Subject: **San Onofre Nuclear Generating Station Units 2 and 3
Docket Nos. 50-361 and 50-362
Amendment Application Numbers 215 and 200
Proposed Change Number (PCN) 536
Request to Revise Technical Specifications to Create
and Implement the Fuel Storage Program**

SPENT FUEL POOL STORAGE WITH NO BORAFLEX
AND
CREDIT FOR SOLUBLE BORON
SAN ONOFRE NUCLEAR GENERATING STATION, UNITS 2 AND 3

FIGURE 3.7.18-1

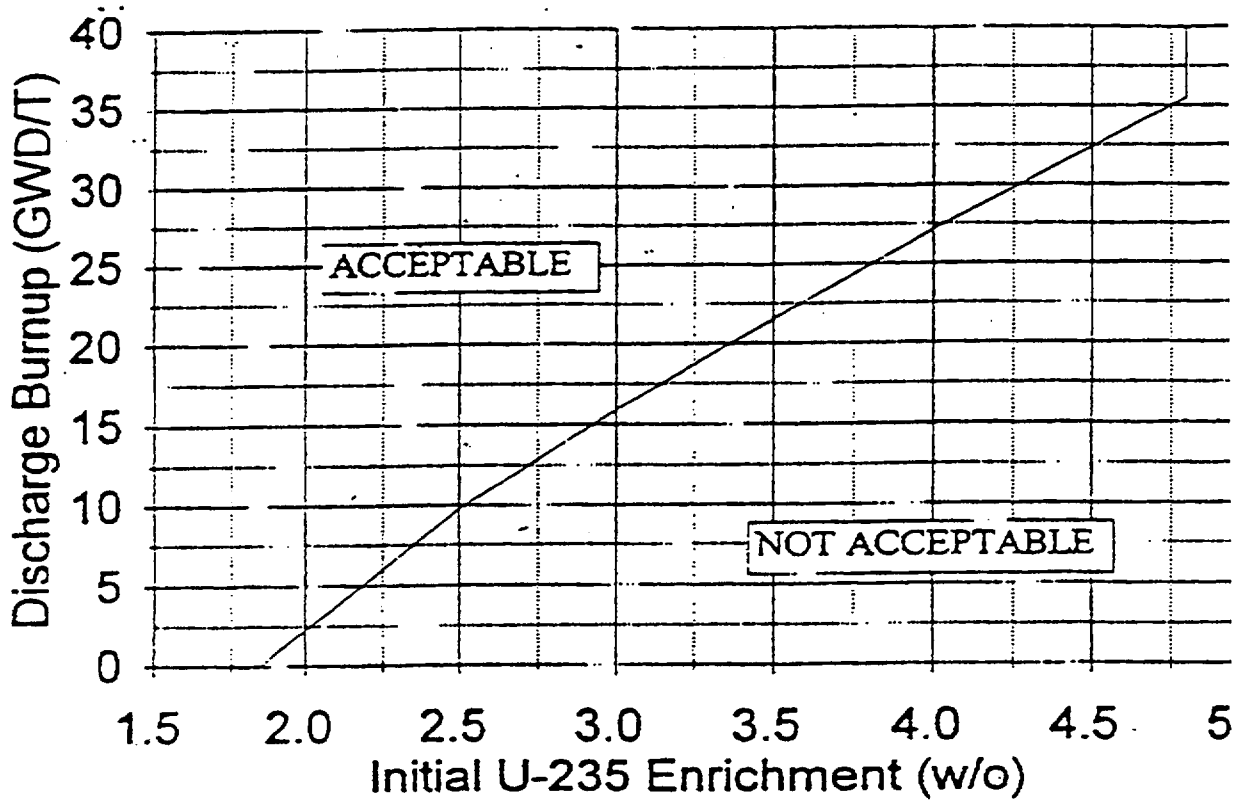
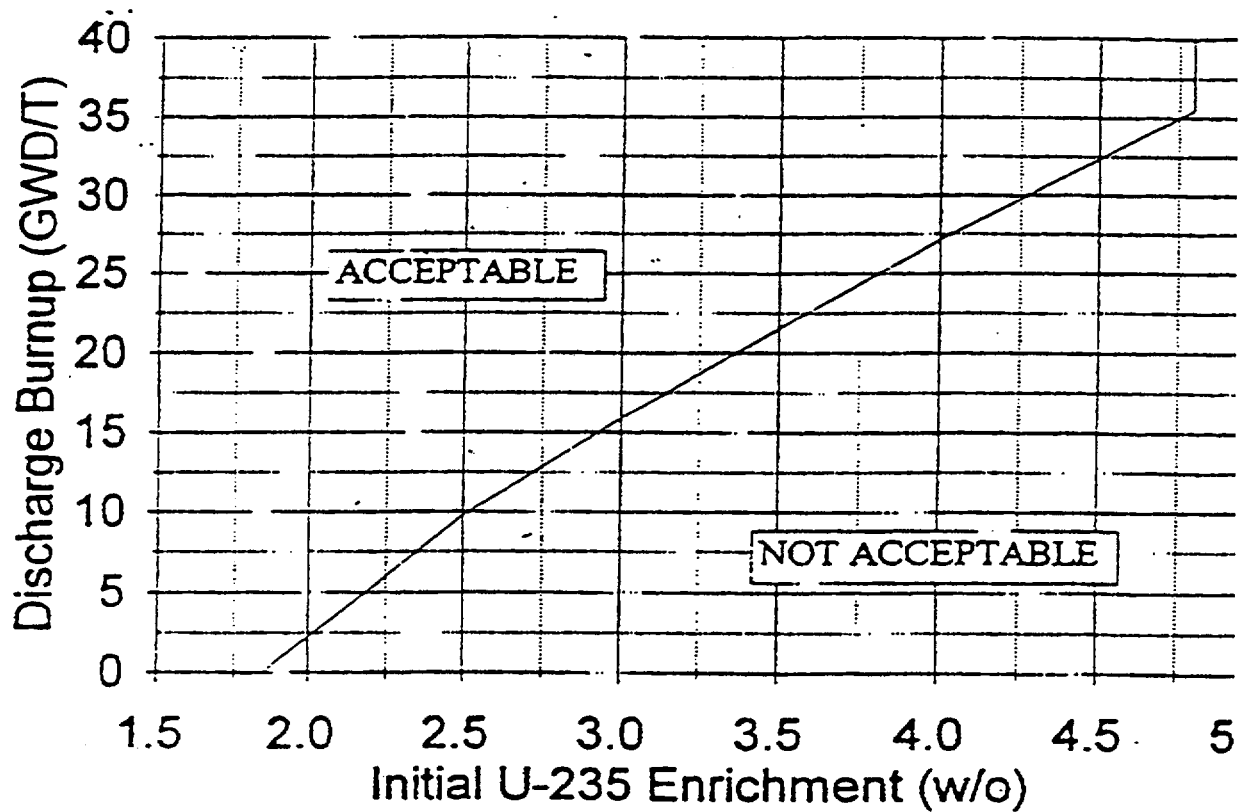
LCO 3.7.18 is completely revised, and Figures 3.7.18-1 and 3.7.18-2 are deleted. Specific storage requirements for SONGS Units 1, 2, and 3 fuel assemblies stored in Units 2 and 3 Spent Fuel Pools (SFP) are deleted and replaced with reference to Technical Specification Section 5.5.2.16, "Fuel Storage Program."

The replacement of Figures 3.7.18-1 and 3.7.18-2 with Section 5.5.2.16 is an administrative change, not a technical change. This change maintains NRC control as Section 5.5.2.16, "Fuel Storage Program," is part of the Technical Specifications, and the Fuel Storage Program will be uniquely identified in Section 5.5.2.16 such that updates to the Fuel Storage Program will require NRC approval.

FIGURE DELETED

~~FIGURE 3.7.18-1~~
